## CRITICAL SERVICE BULLETIN

**SB-185A**

DATE: JANUARY 10, 2005

SUBJECT: **WING ATTACH SHOULDER BOLTS**

**FIGURE 1**

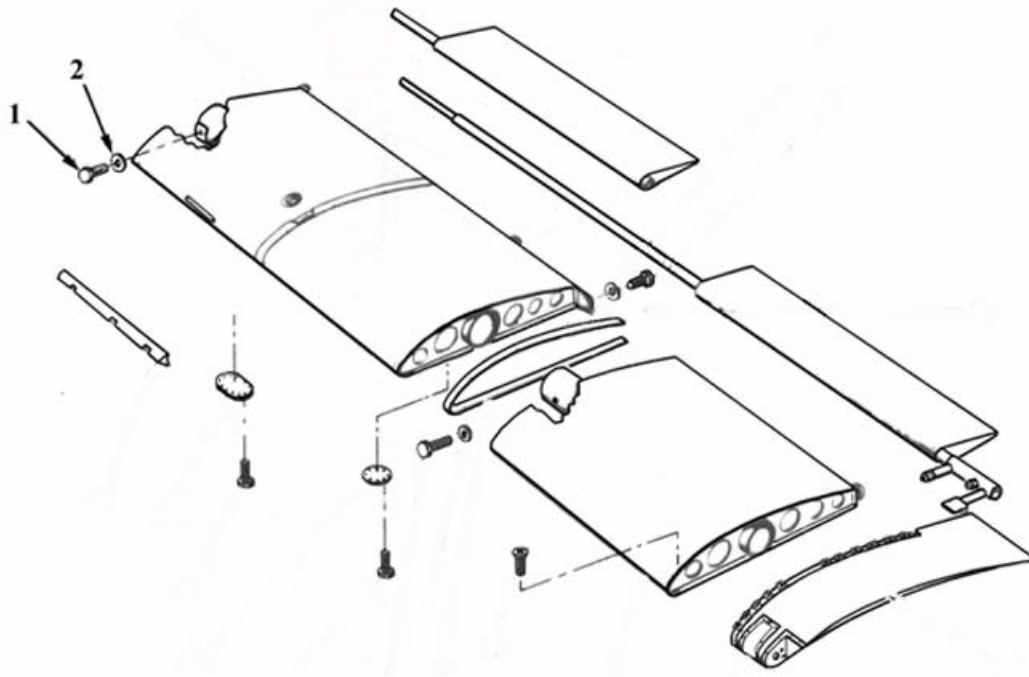
1. Prepare the aircraft for safe maintenance.
  - a. Disconnect the battery.
  - b. Connect the airframe to a suitable ground.
2. Remove the access panel from the lower wing root fairing (Figure 1).
3. From within the wing root, remove the (2) wing attach shoulder bolts (Figure 2) at each wing root main spar.
4. Inspect each of the four P/N 901044-3 wing attach shoulder bolts as follows:

**FIGURE 2**

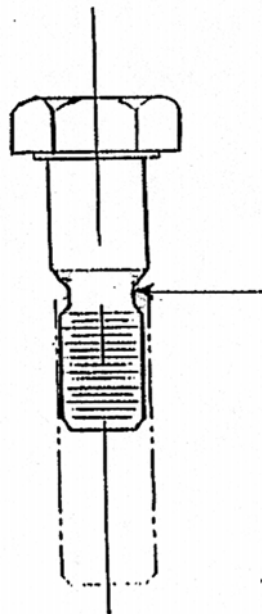
6. Reinstall the shoulder bolts as follows:
- a. Through the access panel under the wing root fairing, install the shoulder bolt and washer and tighten until the head of the bolt contacts the spar.
